City of Rancho Palos Verdes
Rancho Palos Verdes ADA Assessment
Facility Report with Photos

Facility ID: # Curb Ramps

Location: Basswood Ave./Fond Du Lac NE Corner
Photo # 15

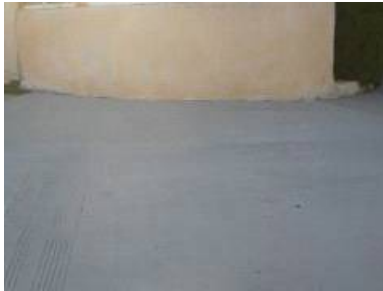
Field Condition	
03A.02A - Width - Accessible route of travel is less than 48" wide (note: 48" wide requirement does not apply to doorways or gates).	1991 ADAAG 4.3.3
Existing Condition: 36" wide.	2004 ADAAG 403.5.1
	2007 CBC 1133B.7.1
	Other 2005 PROWAG-R301.3.1

Corrective Action	
008 - Concrete Landing - Remove non-compliant pavement and replace with new concrete. The landing slope shall not exceed 2% in any direction.	
Additional Comments:

Location: Basswood Ave./Fond Du Lac NE Corner
Photo # 15

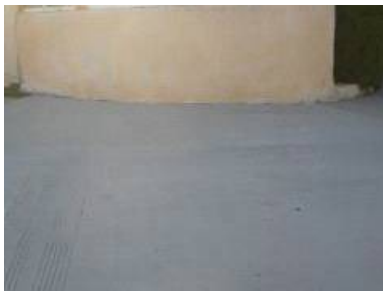
Field Condition	
03A.08 - Running Slope (PAR) - Slope of the pedestrian access route exceeds 1:20. Or slope of the pedestrian access route contained within a street or highway border exceeds the grade of the adjacent roadway. (1:20 requirement does not apply to compliant ramps or where slope of the pedestrian access route contained within a street or highway border does not exceed the grade of the adjacent roadway.)	1991 ADAAG 4.3.7
Existing Condition: 6.8% CS & 12.3% RS.	2004 ADAAG 403.3
	2007 CBC 1133B.7.3
	Other 2005 PROWAG-R301.4.2

Corrective Action	
027 - Site Work - Miscellaneous - See Additional Comments	
Additional Comments: See Keynote 15 for corrective action.

Location: Basswood Ave./Fond Du Lac NE Corner
Photo # 15

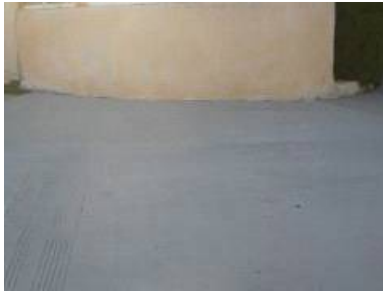
Field Condition	
04.09A - Grooved Border Requirement - Curb ramp does not have a 12" wide grooved border around upper edges of curb ramp and flares to indicate transition from sidewalk to curb ramp.	1991 ADAAG -
Existing Condition: 12 1/2" wide.	2004 ADAAG -
	2007 CBC 1127B.5 item 6
	Other -

Corrective Action
123 - Curb Ramps - Miscellaneous - See Additional Comments
Additional Comments: See Keynote 9 for corrective action.
